Access Compliance Report

Public Rights-of-Way

| Intersection ID: 53003 | Main Street: VICTORIA_BROOK_LN | Cross Street: BRITTANY_DAWN_PL | Location: SE |
| ADA ID: 59FD2F2B876E | Ramp Type: PerpDiag | Initial Pass/Fail: Fail | Overall Compliance: No |

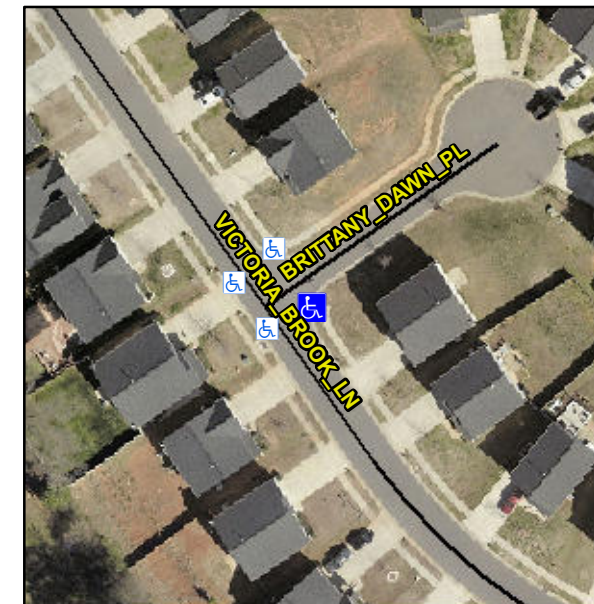
Not Found, R304.5.1, R304.2.2

| Compliance | Description | Data | Compliance | Description | Data |
|------------|-----------------------|------|------------|-----------------------------|------|
| N/A | Ramp Length (in) | 48.0 | No | Ramp Slope (%) | 9.2 |
| No | Ramp Width (in) | 47.0 | Yes | Ramp XSlope (%) | 1.4 |

Remove & Replace Curb Ramp With Two New Directional Ramps or Equivalent.
